GRADING AND EROSION CONTROL PLAN

EXTENDED DETENTION BASIN AS-BUILT
 DANE FRANK, TERRA NOVA ENGINEERING, 2024/10/30

ELECTRONIC STORAGE
 PROPOSED DRAINAGE MAP
 PROPOSED DRAINAGE MAP

COUNTY PRJ #: PPR-20-020
 EPC 11/29/21

INLET ORIFICE PLATE PERFORATED HOLE PATTERN NOT TO SCALE. THIS DETAIL IS FROM THE REV 1 PLANS

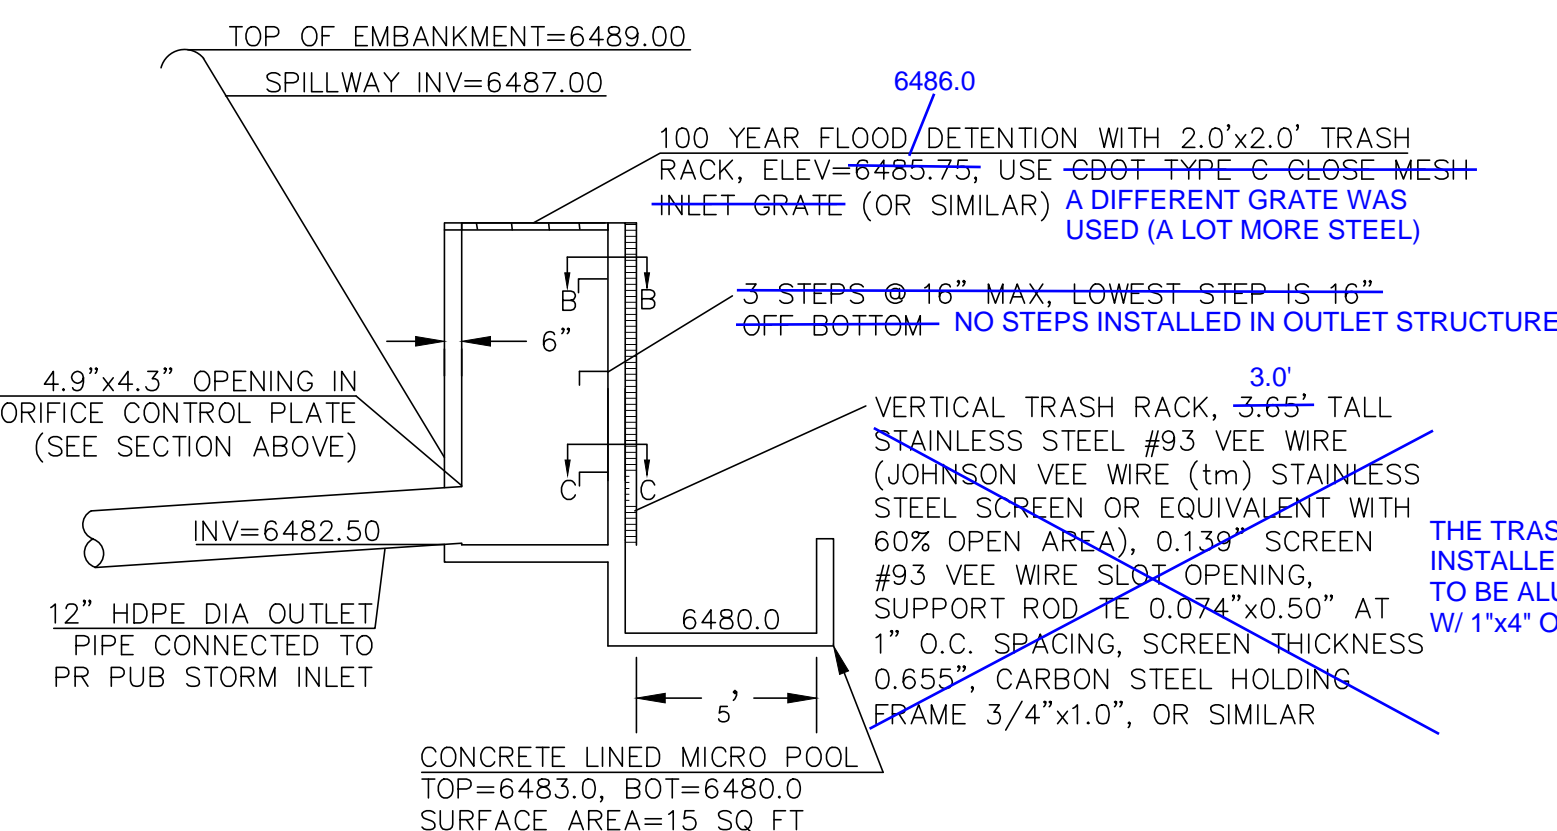
- THE BOTTOM ORIFICE ON THE INLET ORIFICE PLATE IS BUILT 3" HIGH. THE TOP TWO ORIFICES HAD TO BE REDRILLED AND THE CONTRACTOR LEFT THE BOTTOM ORIFICE HIGH DUE TO THE DESIGN ELEVATION HAVING TO GO THROUGH THE CONCRETE AND STEEL OF THE OUTLET STRUCTURE. THE DESIGN SPREADSHEET SHOWS THIS ORIFICE BEING HIGH CAUSES THE DRAIN TIMES TO BE: WQCV 49 HOURS, EURV 84 HOURS, 2 YEAR 73 HOURS, 5 YEAR 81 HOURS, 10 YEAR 87 HOURS, 25 YEAR 89 HOURS, 50 YEAR 88 HOURS, 100 YEAR 87 HOURS, AND 500 YEAR 86 HOURS. THE POND IS SHOWN TO STILL HAVE ADEQUATE STORAGE CAPACITY AND FREEBOARD IN THIS CONDITION.

OUTLET STRUCTURE NOT TO SCALE

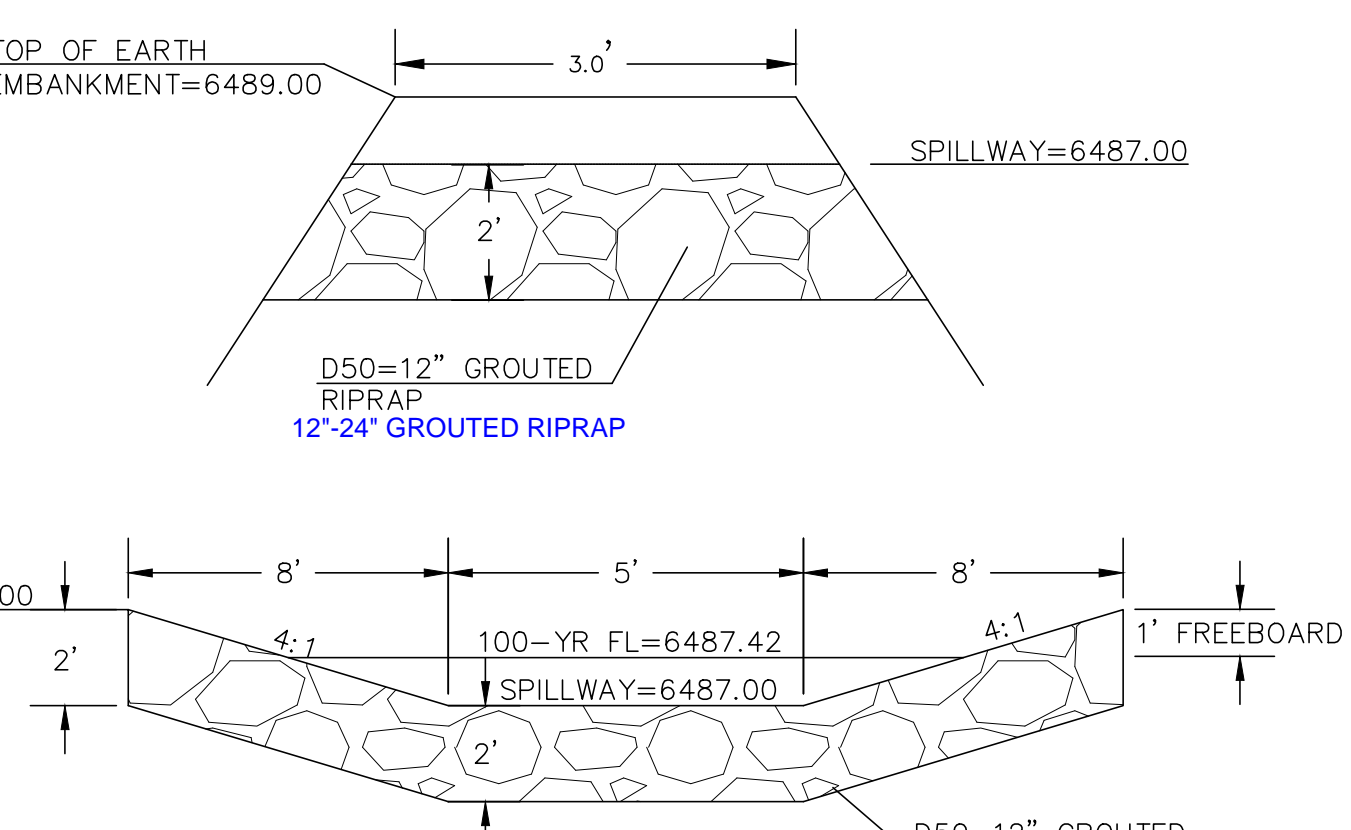
- AS BUILT REDLINES ARE SHOWN IN BLUE.
- THE FINAL GRADING WAS A LITTLE DIFFERENT THAN THE DESIGN, AND THE TOP OF THE OUTLET STRUCTURE WAS BUILT 6" HIGH. CHECKING THE AS-BUILT NUMBERS WITH THE DESIGN SPREADSHEET SHOWS THE GRADING AND OUTLET STRUCTURE TOP WILL FUNCTION AS INTENDED, WITH THE WATER SURFACE ELEVATIONS CHANGING A LITTLE.
